## ADDENDUM #2

Date: August 7, 2008  
To: Contractors  
From: Jeff Reddoor, Project Manager, DFCM  
Reference: Facility Management Building  
Southern Utah University – Cedar City, Utah, Utah  
DFCM Project No. 08115730  
Subject: Addendum No. 2

**DFCM Project Number: 08115730**  
**SUU Facilities Management Building**

Addendum Number 2

**SITE GRADING PLAN FOR:  
SUU FACILITIES MANAGEMENT OFFICE**  
400 S. 6TH STREET & 1275 W. STREET  
CEDAR CITY, UTAH 84702  
LOCATED IN THE NW 1/4 OF THE SE 1/4 OF SECTION 15 RIW T36S S16E1

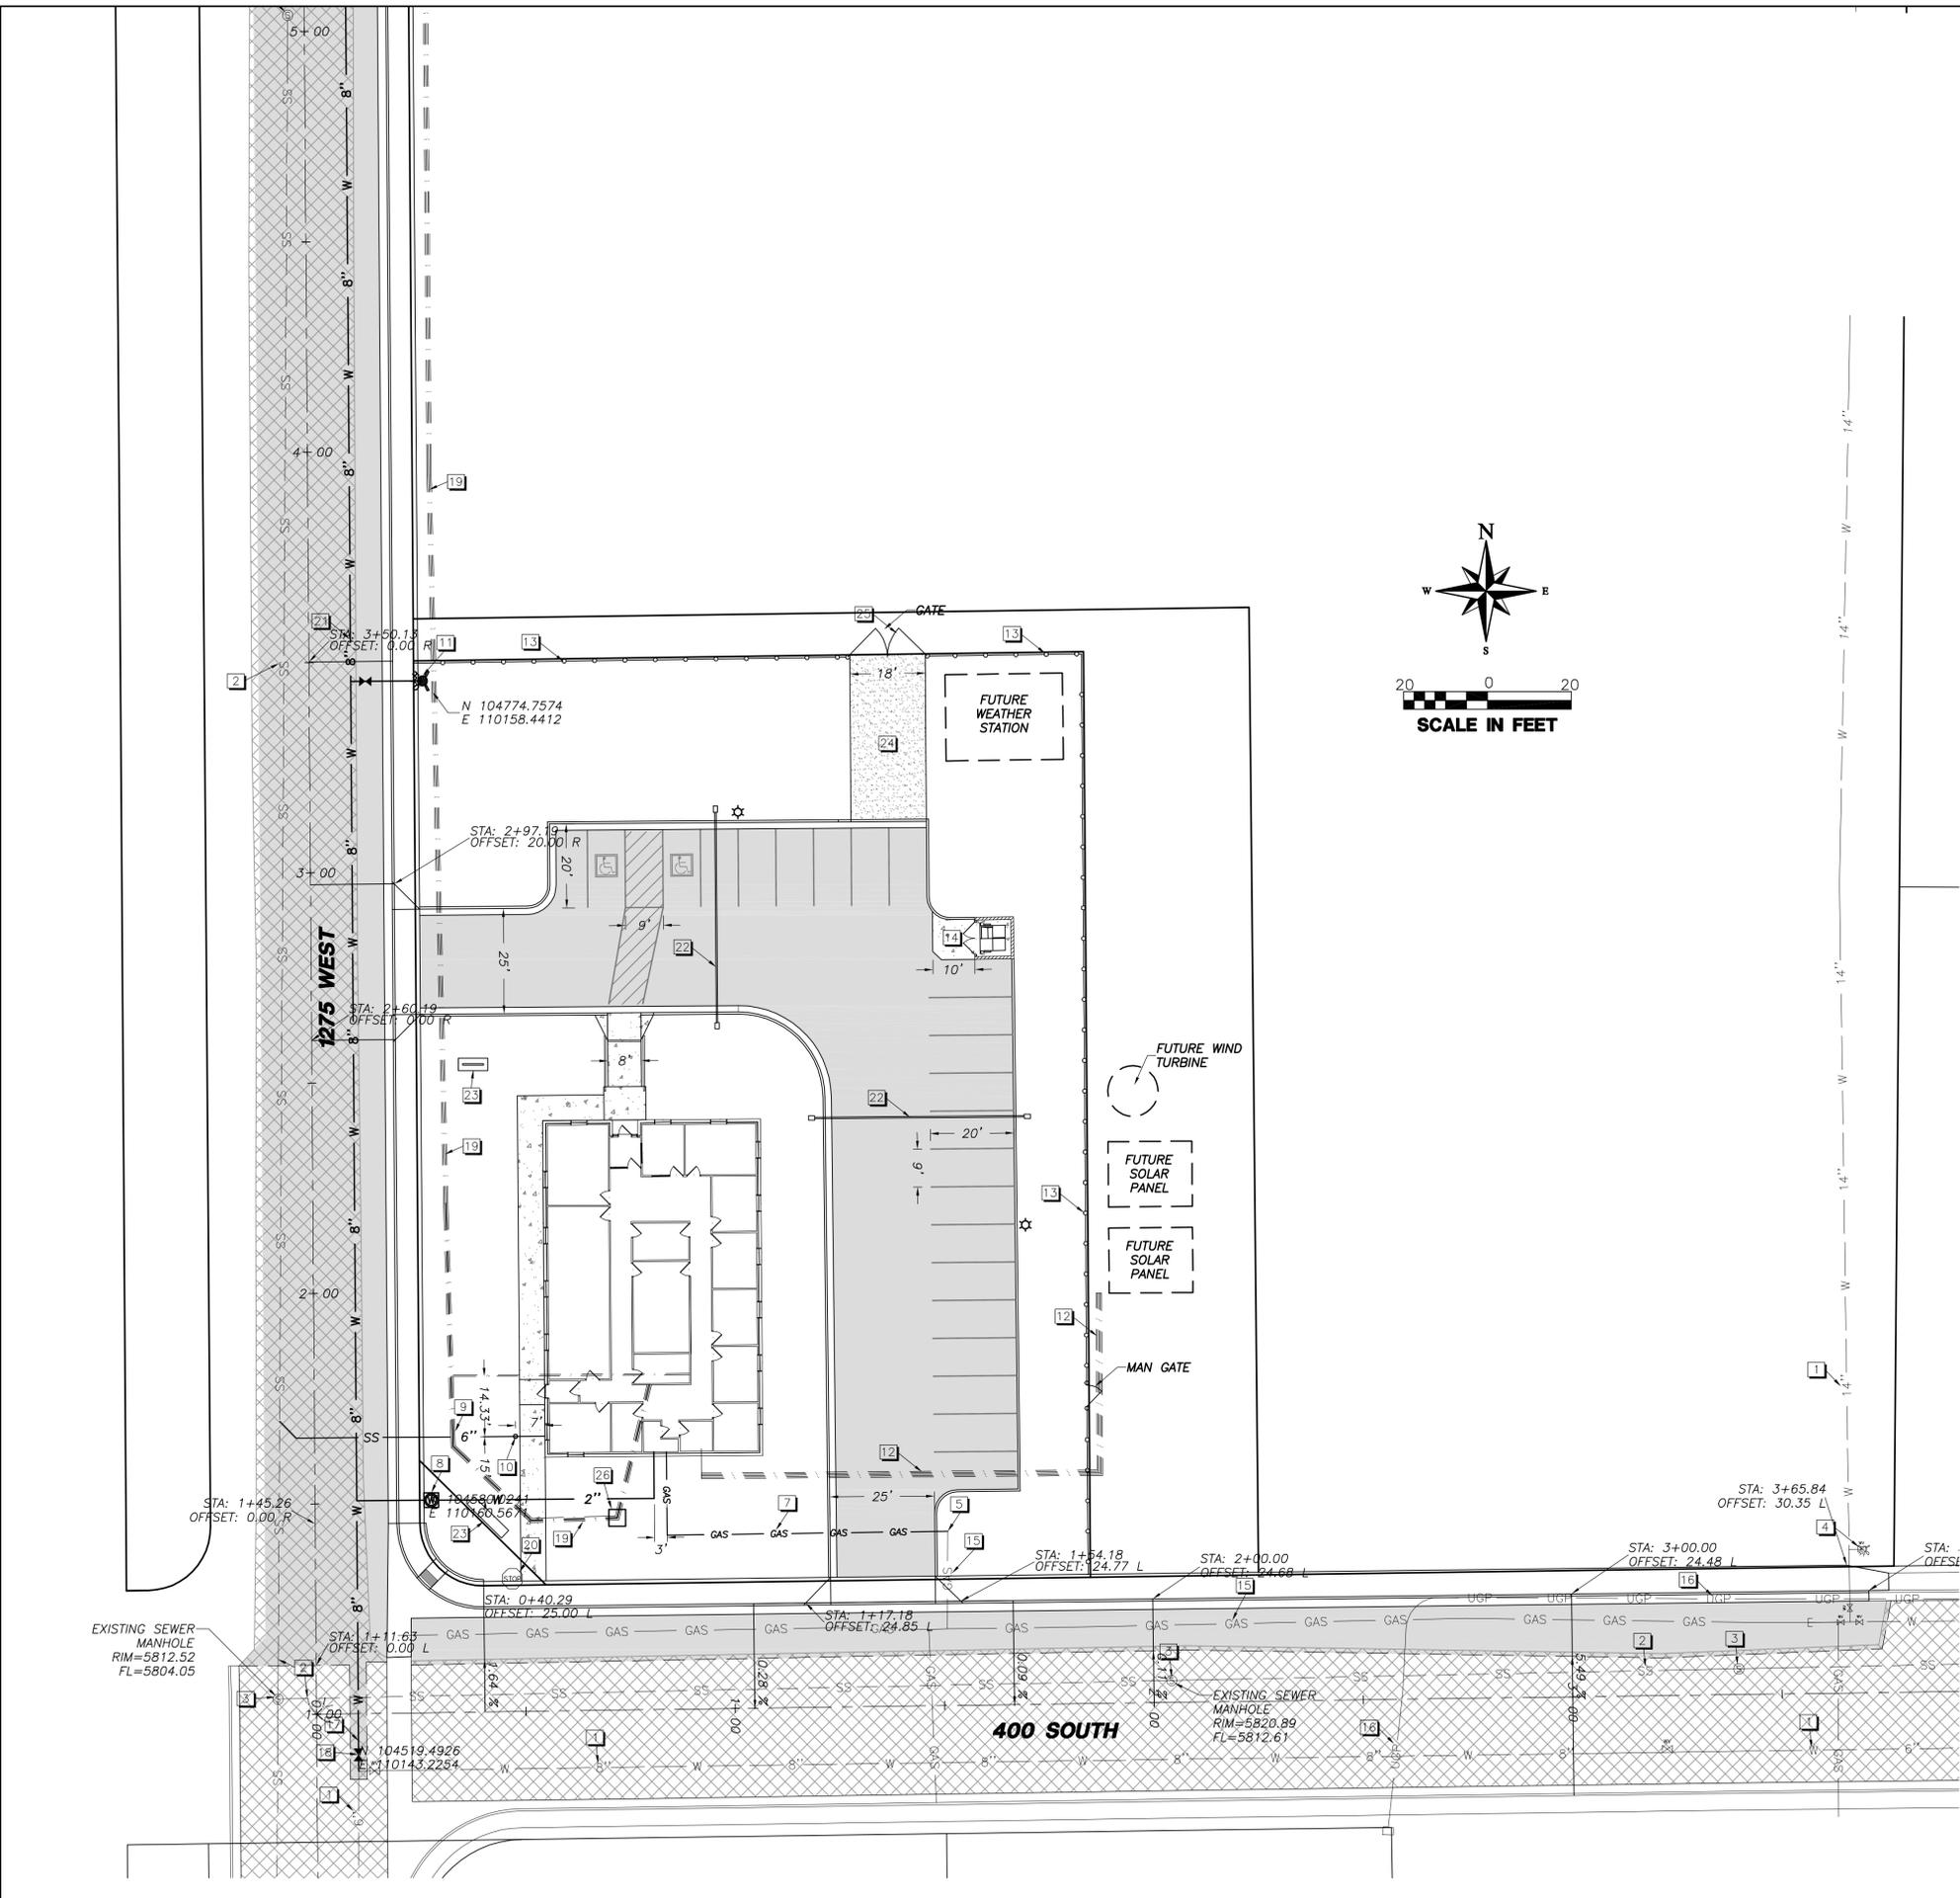
5. Civil Site Items
- a. The handrail detail identified on Sheet C7 is located on Sheet C2, of the bid set, as Key Note 12.
  - b. The new gravel drive identified as Note 7 on Sheet C2 in the Northeast corner of the construction site will be 8" of road base over 8" of Type 1 gravel.

SHEET TITLE:  
 ENLARGED  
 PARTIAL  
 ELEVATION

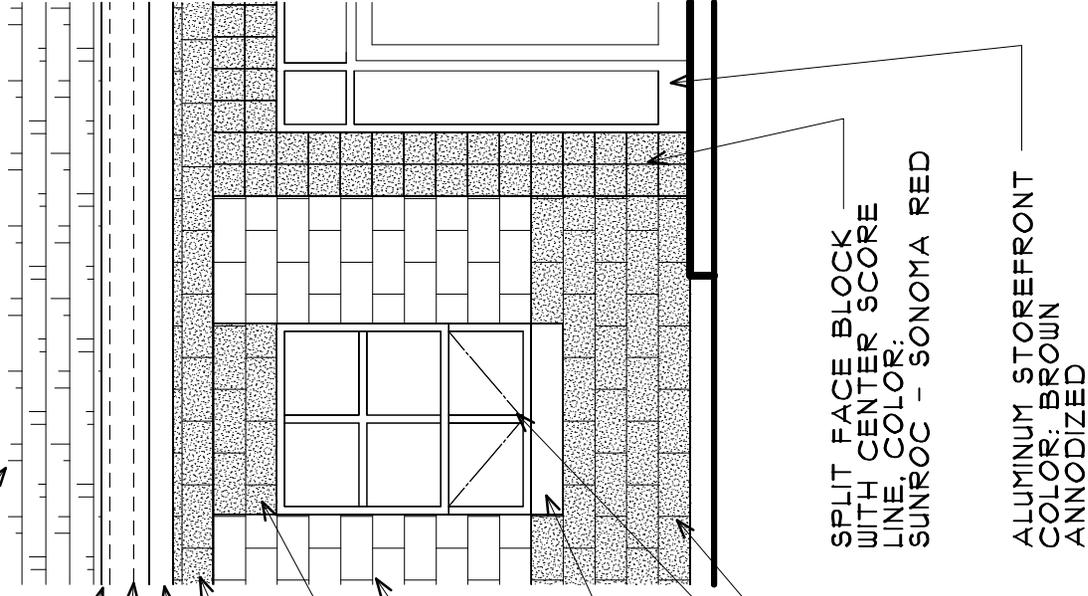
1. Finish Material Items
  - a. Exterior Finish Materials –
    - i. Exterior Building Colors - See attached detail AD001.
    - ii. Roofing - Elk Building Products, Prestique Plus High Definition, 50 year Warrantee, Color: Barkwood

SHEET TITLE:  
TRASH  
ENCLOSURE  
PLAN

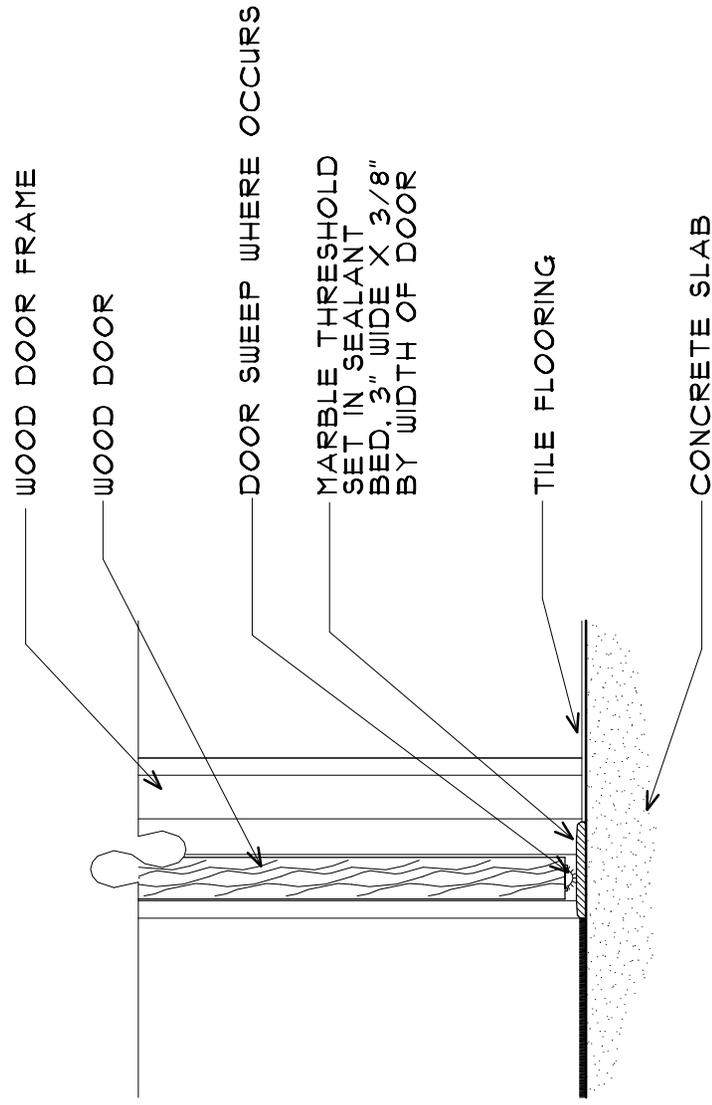
6. Architectural Site Items
- a. The trash enclosure does not have a gate. See attached drawing, AD003, for additional information concerning the trash enclosure.
